ENVIRONMENTAL REVIEW TEAM REPORT

PROPOSED CARR HOTEL COMPLEX BRIDGEWATER, CONNECTICUT

**PROPOSED CARR HOTEL COMPLEX
BRIDGEWATER, CONNECTICUT
APRIL, 1984**

FIGURE 2 SIMPLIFIED SITE PLAN

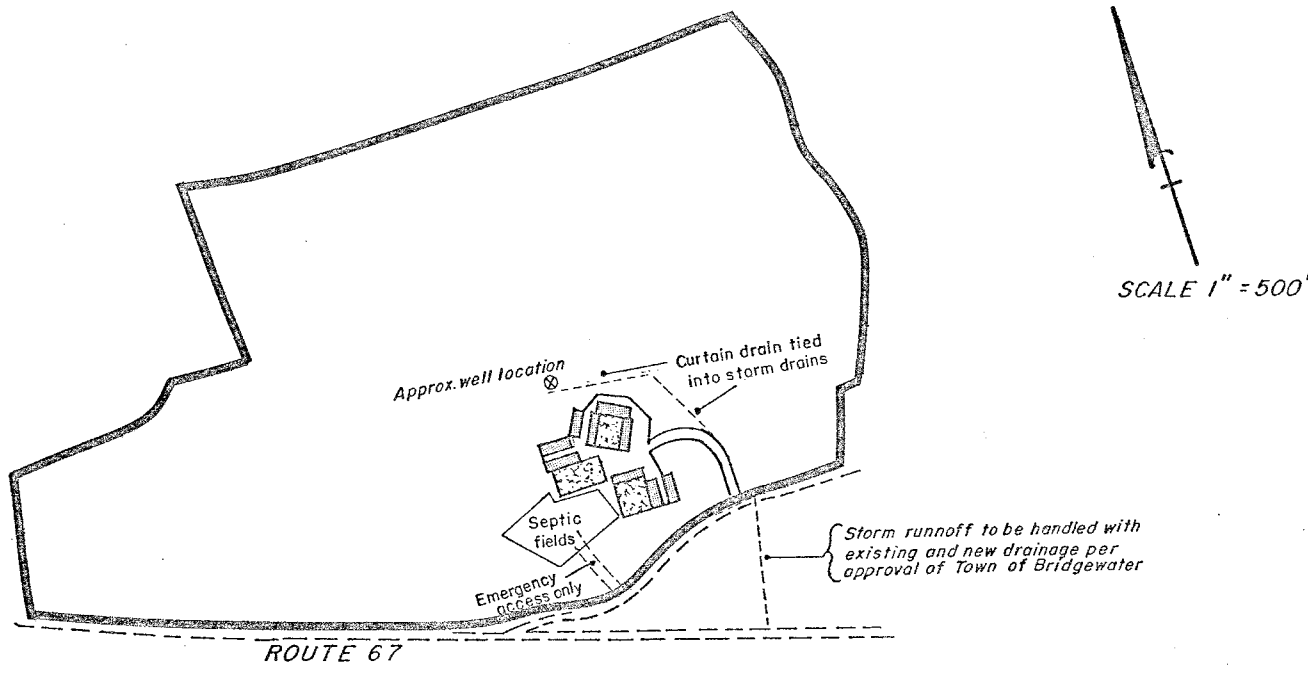
The proposed alignment of the hotel buildings will create an extensive cut slope on the northwest side of the buildings. This slope will be difficult to stabilize. A realignment of the buildings along the existing contours of the land will reduce necessary land grading, reduce necessary erosion controls, provide for possible solar heating of buildings and generally be more cost effective.

The planned subsurface drainage will be necessary to control seepage in cut slopes. The drain should be installed on a slight grade upslope from all buildings and all cut slopes. If the drains are installed as shown, with steep slopes on the pipe, they will not be working to their fullest capacity and will not pick up all the seepage.

FIGURE 4 WATERSHED BOUNDARY MAP

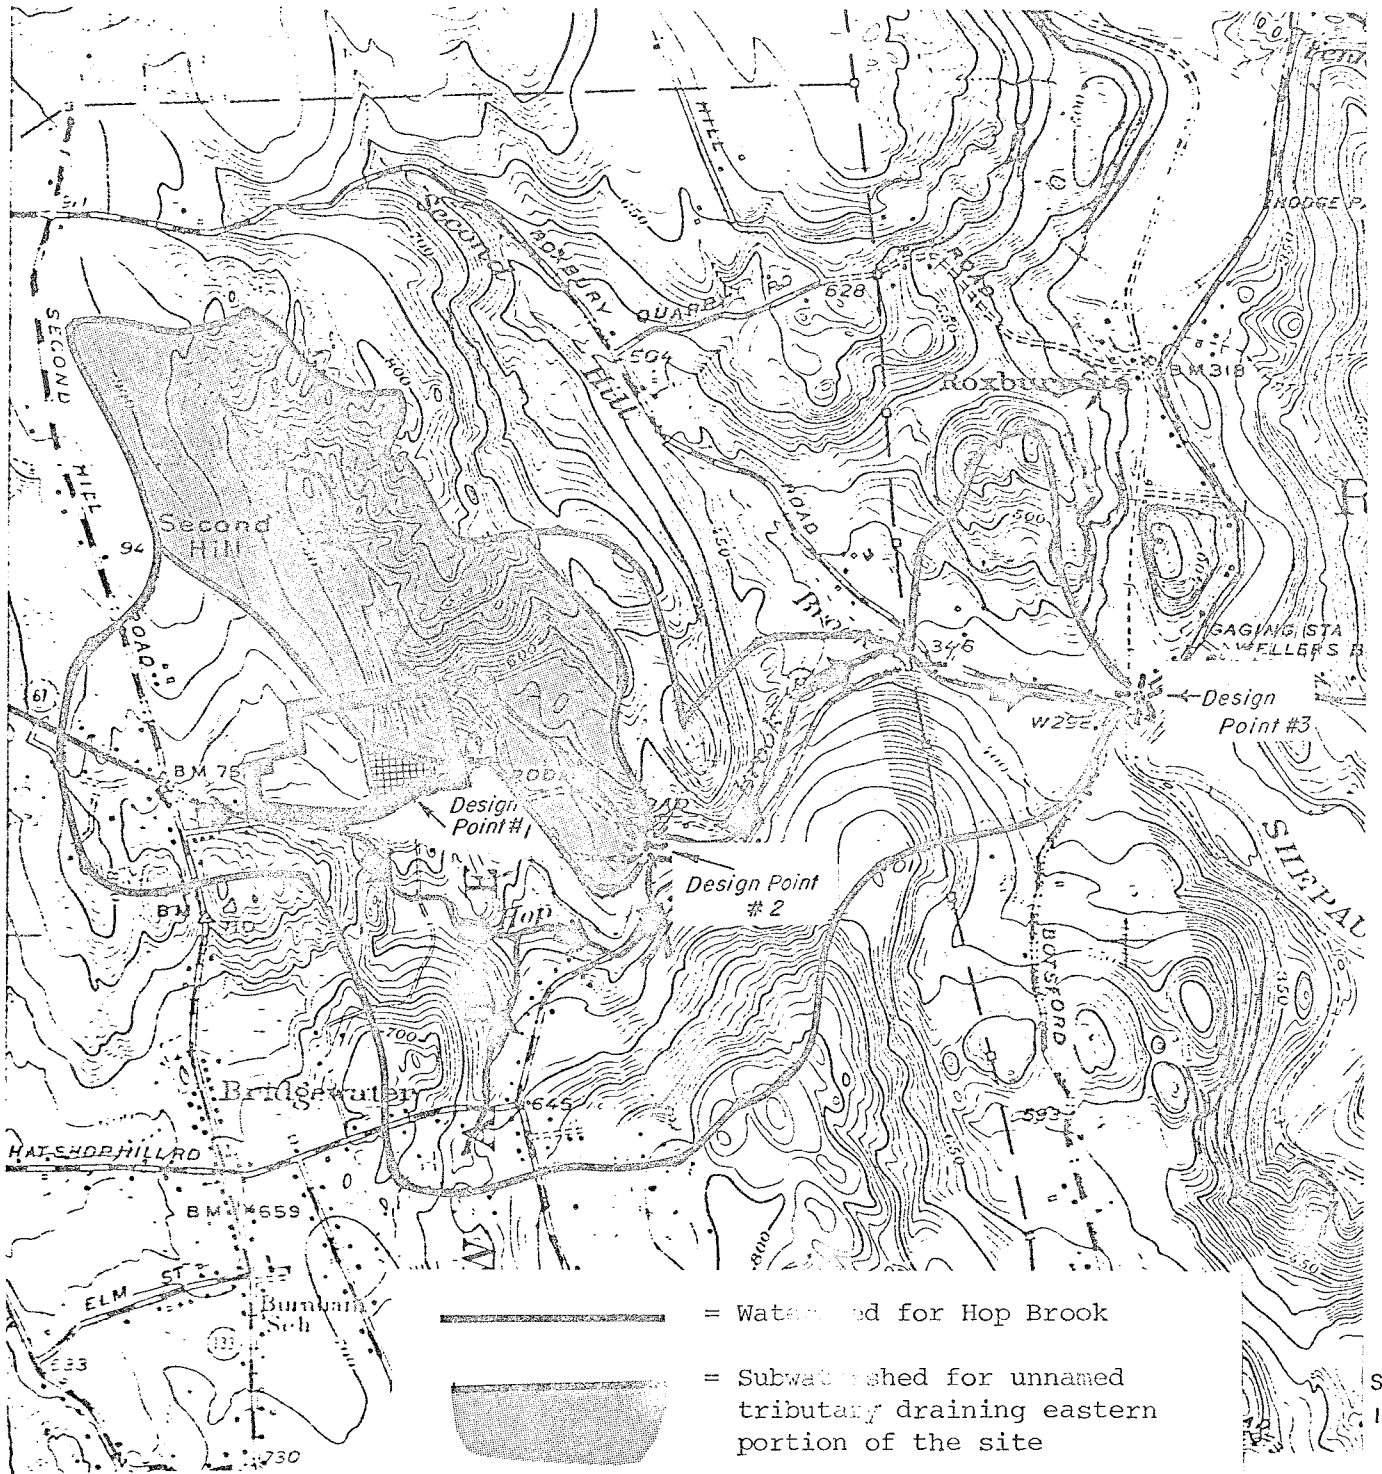
Approximately 60 percent of the site in the southern and western portions (which includes the proposed hotel/restaurant complex) lies within the watershed of Hop Brook. Surface runoff flows generally southward by sheet flow and/or by intermittent drainage swales into Hop Brook. Hop Brook, which traverses the southwest corner of the site for about 825 feet is a tributary to the Shepaug River. Surface runoff in the northeastern part of the property flows mainly by sheet flow and/or intermittent drainage swales into an unnamed tributary of Hop Brook (see Figure 4).

The results of the Team geologist's calculations, shown below for the design point chosen, should be considered as ballpark figures with regard to the estimated peak flows and runoff volumes. The calculated percentages of increase should be fairly close, however,

The moderate level increases shown in the tables above are significant enough to merit the careful consideration of stormwater management on the site. It should be noted that the peak flows listed after development conditions do not take into account possible piping or other channeling. Stormwater routing would increase these flows to some extent.

It is, therefore, suggested that the applicant be required to submit detailed hydrological information prior to approval of the proposed complex. This information should include pre- and post development runoff estimates from the site for the 10, 25, 50 and 100 year storm events. Because the Town would like to see off-site flows following the development maintained at present levels, a possible method for controlling runoff on the site might be to establish a detention basin or basins which would alleviate peak flows. Detailed design specifications for all stormwater detention basins should be submitted and reviewed by appropriate town officials.

FIGURE 5 REVISED SOILS MAP

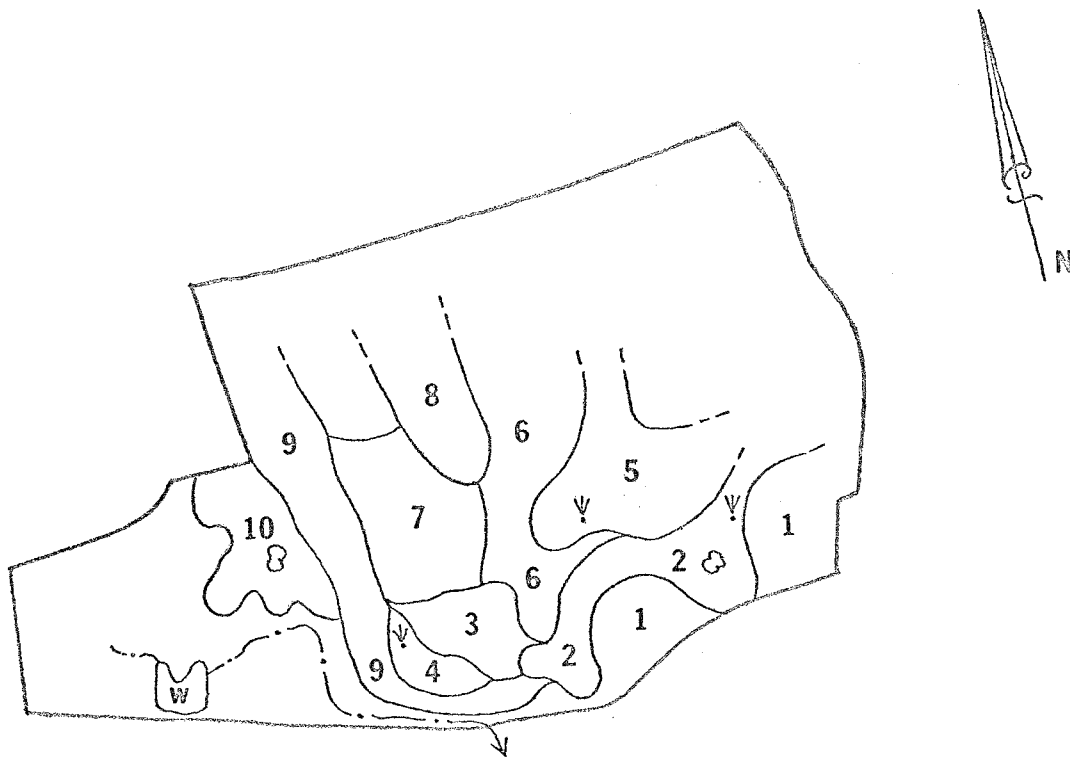
The proposed layout of the complex appears to have the buildings located on portions of map units 1, 2, 6, 7. The proposed septic system for this complex appears to be located on Units 2 & 3.

The area designated for the on-site septic system has the limitation of a seasonal high water table. The seasonal high water table in map Unit 2 is probably greatly influenced by the subsurface flow of water into this area from the dense basal till hillside north of the site. Portions of the proposed system that fall into map Unit 3 are also limited by a perched seasonal high water table and a dense, slowly permeable substratum.

It appears the next most suitable area for subsurface sewage disposal on the property (after map Unit 2) is map Unit #10. However, map Unit #10 has many of the same soil limitations that are found in map Unit 2. This map unit (#10) has the advantage of being larger in size, but the disadvantage of bordering an area of wetlands, and is farther from the proposed buildings complex. In the event either of these areas are developed, they would benefit from a tiled diversion upslope to reduce the amount of subsurface water entering the map units from the hillside.
